JDE Project 20113

**RE: Traffic Impact Study Addendum
Rintala Quarry, City of Greater Sudbury**

JD Engineering prepared a traffic impact study for the proposed Rintala Pit and Quarry on a site located at 787 Municipal Road 4 (Fairbank Lake Road) in the City of Greater Sudbury (dated December 15th, 2020). This letter is intended as an addendum to the TIS, to address the City comments provided in the May 5th, 2021 email (File 751-8-21-01, Regional Road. 4. Whitefish). Excerpts of the 1st Submission Comments are provided in the **Appendix**.

Total (2030) AM Peak – WB on Fairbank Lake Road at Site Access

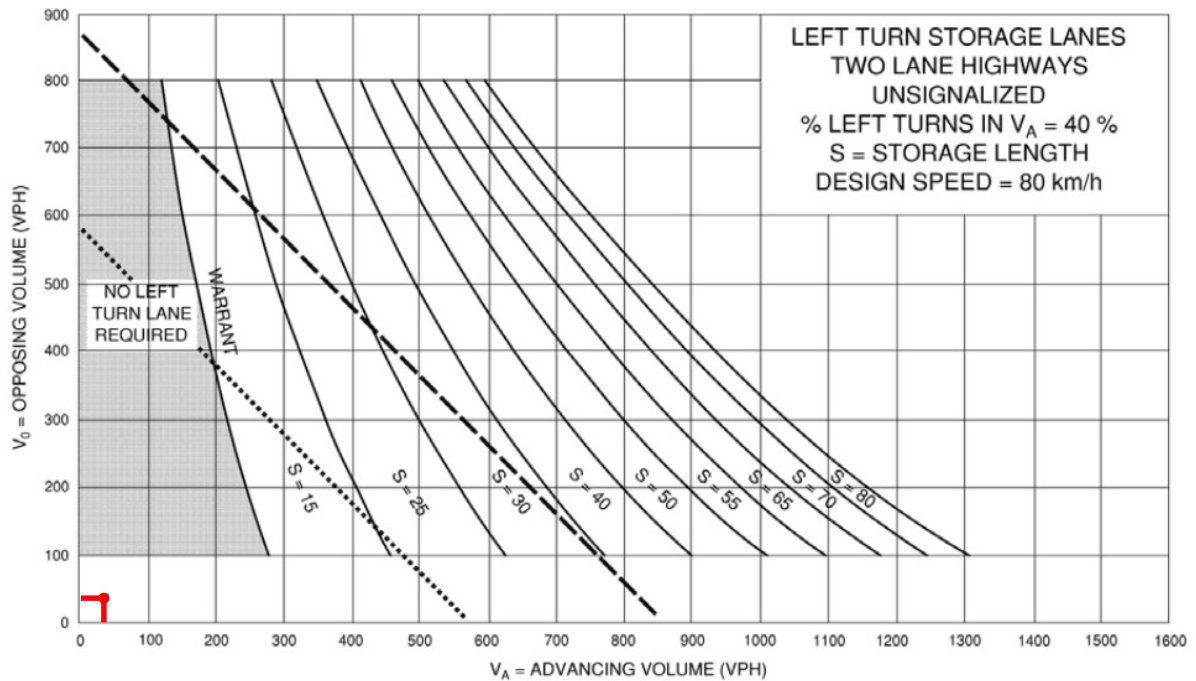
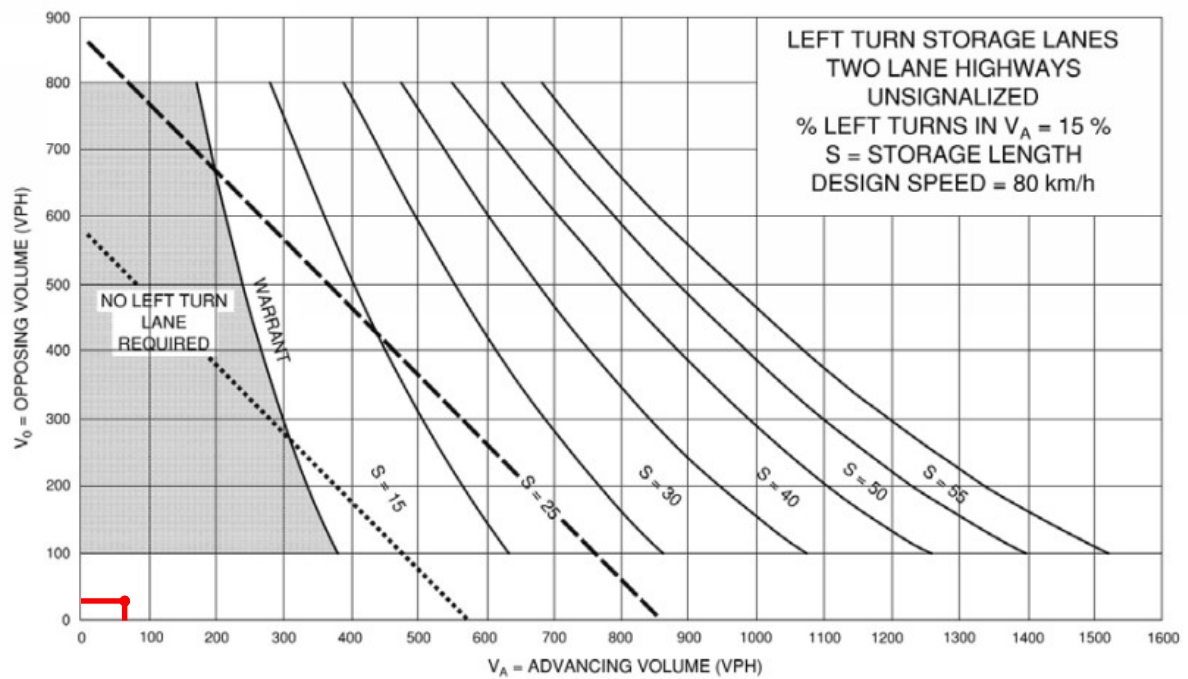
On page 15 of the traffic impact study it is indicated that the determination of the need for turn lanes was done through Synchro analysis. We will require the study to use MTO turning lane warrants for that analysis.

An analysis was completed for left turn movements at the Fairbank Lake Road / Site Access intersection under the Total 2030 horizon year (worst-case scenario) based on the criteria outlined in Appendix 9A of the Ontario Ministry of Transportation Design Supplement for TAC Geometric Design Guide for Canadian Roads June 2017 [MTO DS].

Based on the above noted criteria a left-turn lane is not warranted at the study intersection (results provided in the **Appendix**).
